Product Change Notification

51060HIC125 - Humidity Card, 5-10-60%, 125/Can

Date: February 4, 2019

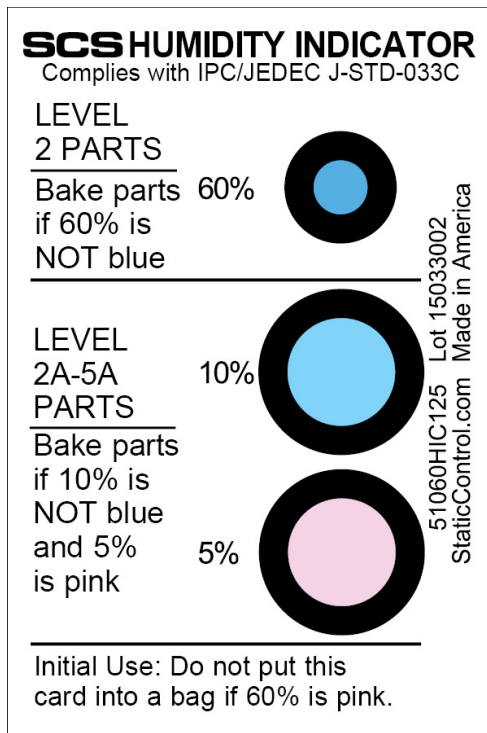
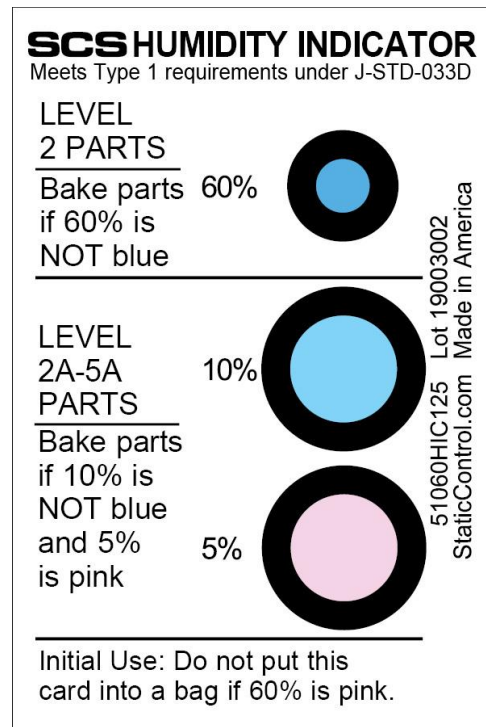
The **51060HIC125** humidity indicator card will now be marked with “Meets Type 1 requirements under J-STD-033D”. This will replace the previous wording, “Complies with IPC/JEDEC J-STD-033C”.

This is strictly a visual change to reflect compliance with Type 1 requirements for **IPC/J-STD-033D**. There has been no change to the fit, form or functionality of the product.

Key Dates/Traceability: Product marked with 1905002 date lot code, and date lot codes following (1905003, 1905004, etc.) will reflect these new changes.
